CITY OF SMYRNA COMMUNITY DEVELOPMENT DEPARTMENT MEMORANDUM

RE: REZONING CASE Z18-019 – 2875 Spring Hill Parkway

Development of a seven-story, 103,685 sq. ft. boutique hotel.

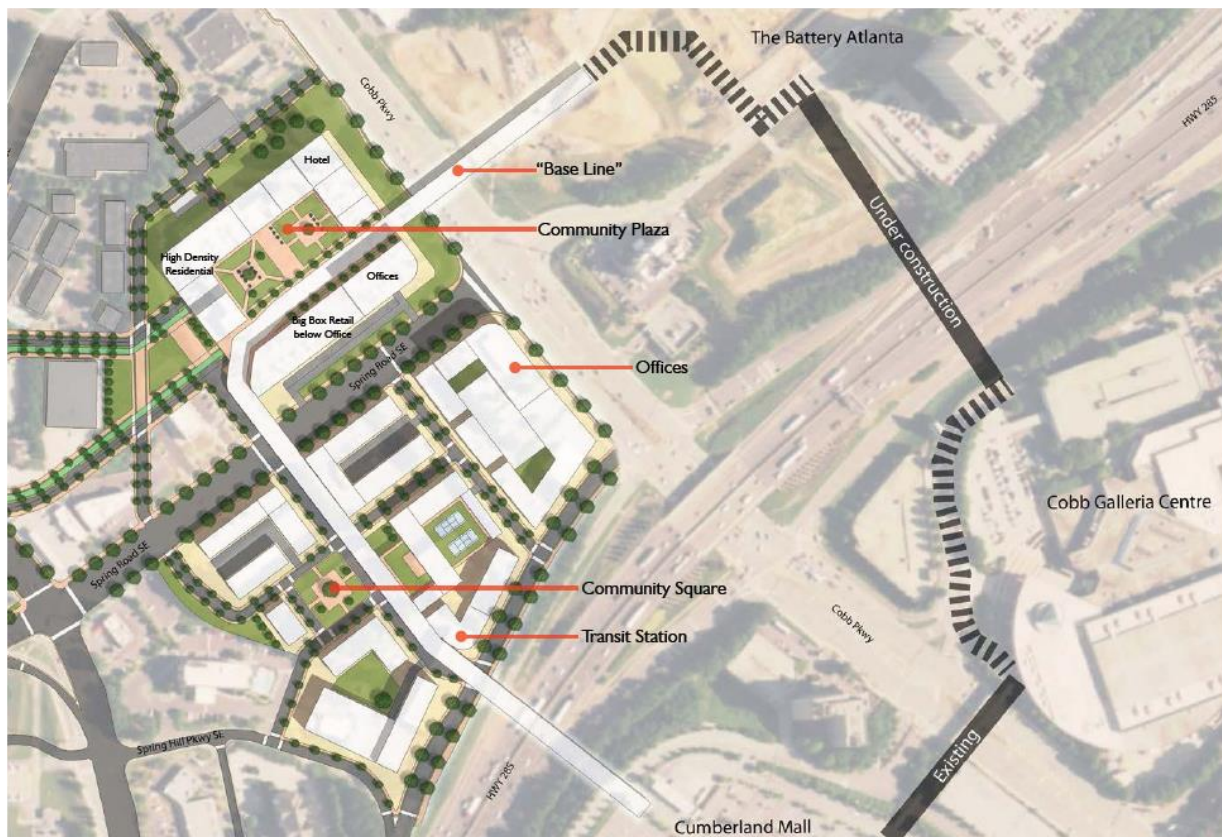
The City's Fire Marshal's Office has reviewed the proposed plan and believes that will be able to serve the zoning proposal provided that it meets the City & State Fire Codes. The Fire Marshal's Office has provide the following items that need to be addressed with respect to the site plan to provide appropriate emergency response and access:

1. The applicant shall provide a full turning model for fire truck access with the specifications of the City's largest truck;
2. All radii within the development shall be a minimum of 25';

3. The site will be required to meet ADA requirements for access and parking; and
4. The building and parking deck will be required to have a fire sprinkler system.

This development will need to address all the issues described above and meet all the city requirements with regards to the fire code.
